VALUE ENGINEERING CHANGE PROPOSAL MISSOURI DEPARTMENT OF TRANSPORTATION

Date <u>2/25/09</u>
Contract ID 081121-404	Job No. <u>J412200</u>
County Jackson	Original Bid Cost \$1,147,047.00
Contractor Collins & Hermann, Inc	By Jeremy Knernschield
Designed By MoDOT	Phone 913-621-3906
VECP# 09-21 (to be complete	d by C.O.) VECP Or VECP/PDU

Contract ID: 081121-404
Job No.: J412200
County: Jackson

Value Engineering Change Proposal Option 3

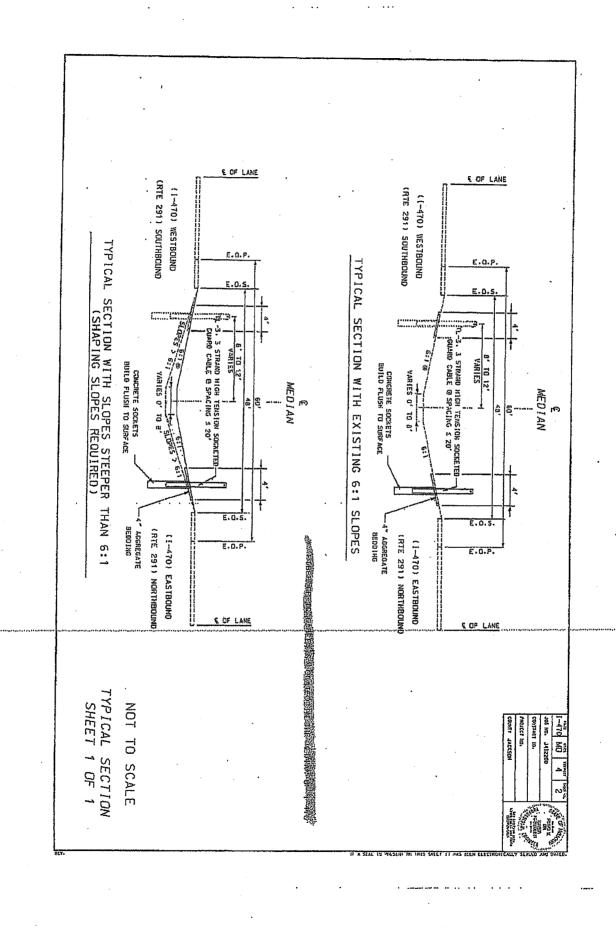
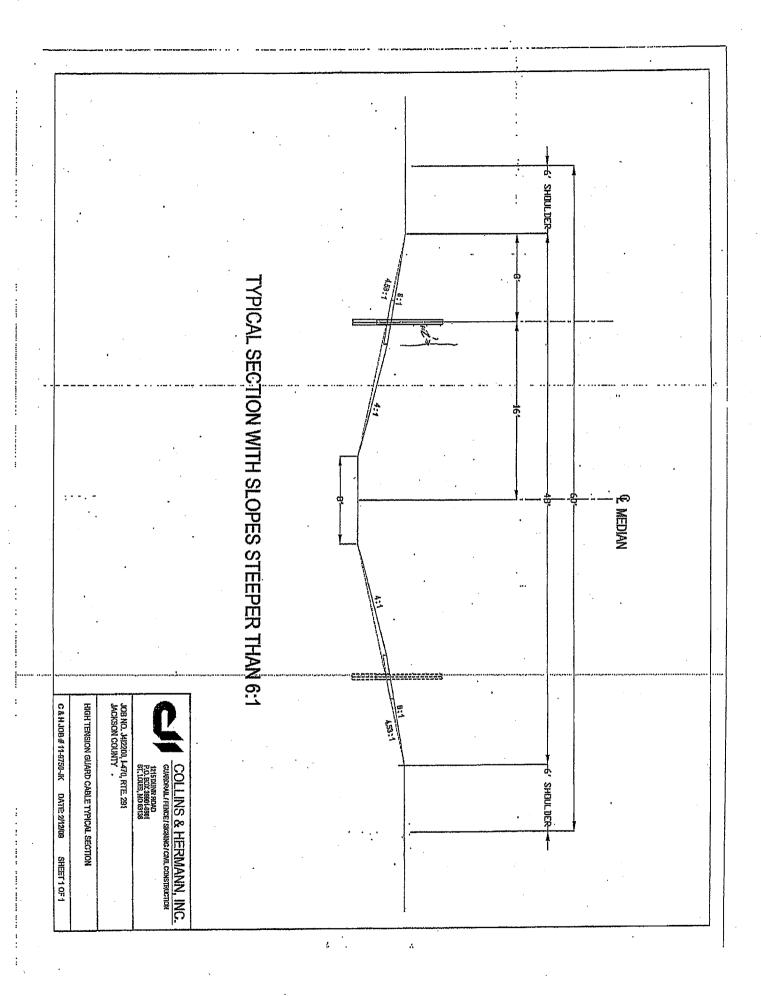
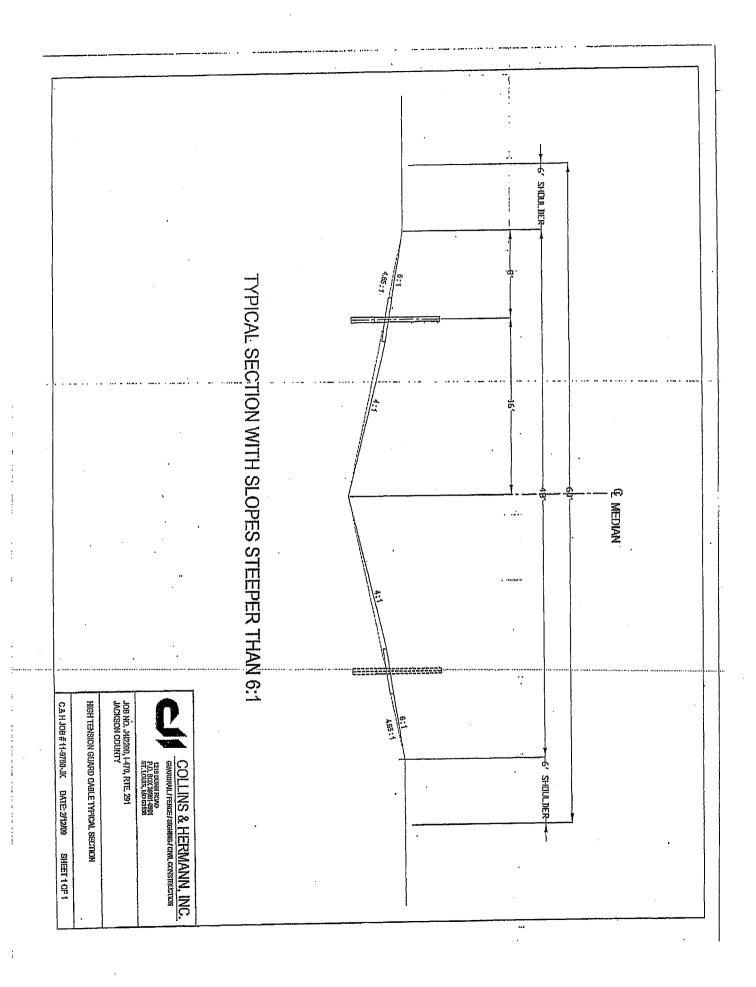
We reviewed the "Typical Section" drawing, on Sheet 1 of 1, for Project Job No. J412200, and on that page, the median drawings are not drawn to scale, as is identified on the drawing. However, the drawing indicates that measurements/placement should be made from the center of the ditch (ie; varies from 8-ft to 12-ft). (See drawing enclosed.)

Our recommendation is to measure and place the cable barrier from the Edge of Shoulder (EOS). This will accomplish several things:

- 1. If you measure from the center of the ditch, you will end up getting a "zig-zag" effect with the cable barrier being anywhere from 8-ft to 16-ft from the EOS. By measuring from the EOS, your placement will be more uniform, thus eliminating the need to make 50:1 transitions every time the cable barrier follows the bottom of the ditch-line.
- 2. The cable barrier will perform better. By having the cable barrier 8-ft from the EOS, you will be able to capture the vehicle sooner before it becomes too unstable, which could cause the cable barrier to be less effective.

The question also came up as to how far or close to the edge of shoulder (EOS) could the cable barrier be placed? We recommend placing it 8-ft from the EOS. By doing so, you will eliminate some nuisance hits, versus having it 4-ft off the shoulder.

As long as the slope is 6:1 or flatter on the "approach-side", there are no restrictions on how close or far away from the EOS you can place the cable barrier, so long as you do not place it from 1-ft to 8-ft. up from the bottom of the ditch. This "restricted area" is based on the FHWA recommendations.

With that being said, as long as the approach-side of the median is 6:1 slope or flatter, you could place the barrier 8-ft from the EOS, so long as you don't violate the "restricted" zone on the backside (ie; within the 1-ft to 8-ft up out of the bottom of the ditch).

Speaking of the "backside approach", you don't have to have the same 6:1 slope coming up from the backside, nor do you even have to have a symmetrical ditch at all. You can have an asymmetrical ditch with a 6:1 slope on the approach side and a 4:1 slope on the backside. This could save the District a lot of unnecessary dirtwork, drainage work, etc. and would not have an adverse impact on the performance of the cable barrier system.

In recap, we recommend placing our cable barrier system 8-ft from EOS in order to create a more uniform, more effective cable barrier that will also minimize nuisance hits.
